**From:** Arboriculture Team  
**Sent:** 28 January 2022 17:11  
**To:** Bond, Peter; Strategic Planning  
**Cc:** Hampshire Arb Consultancy  
**Subject:** Hamble Airfield HCC/2021/0787 our ref SS22180

Hi Planning,  
 Thanks for the opportunity to comment on this application HCC/2021/0787.  
 I have a few comments and requests:

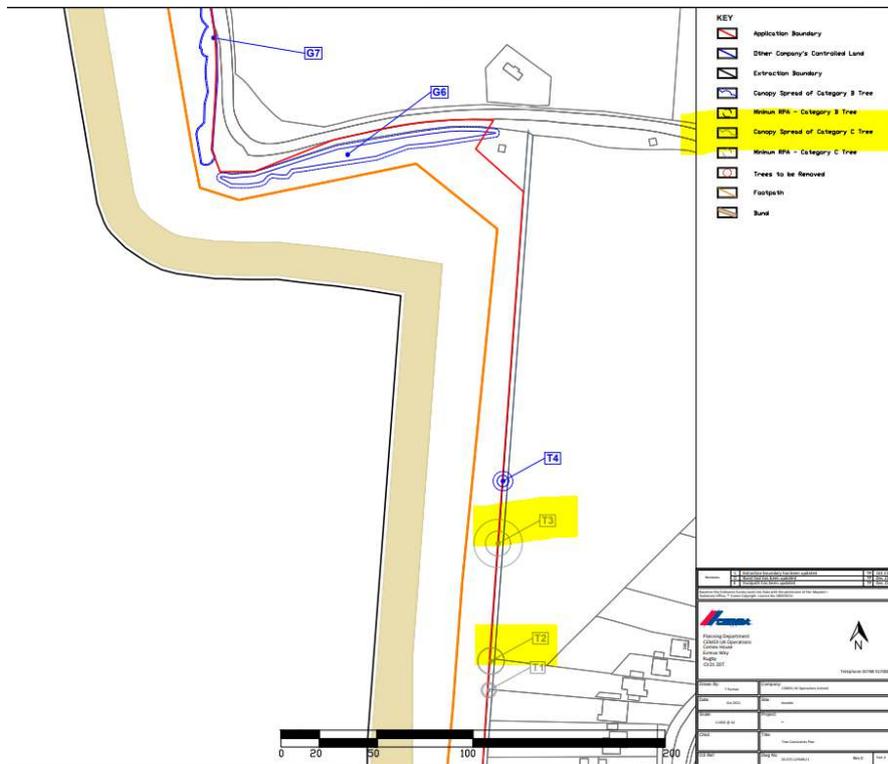
6. I believe that at least one of the trees proposed for removal to create the new access is owned and manged by Hampshire County Council:

If this is the case, the Highway Tree policy (copy attached) will be triggered and CAVAT valuations will be required if it is agreed that trees can be removed to facilitate the proposal. HCC agreement must be gained prior to any works taking place.
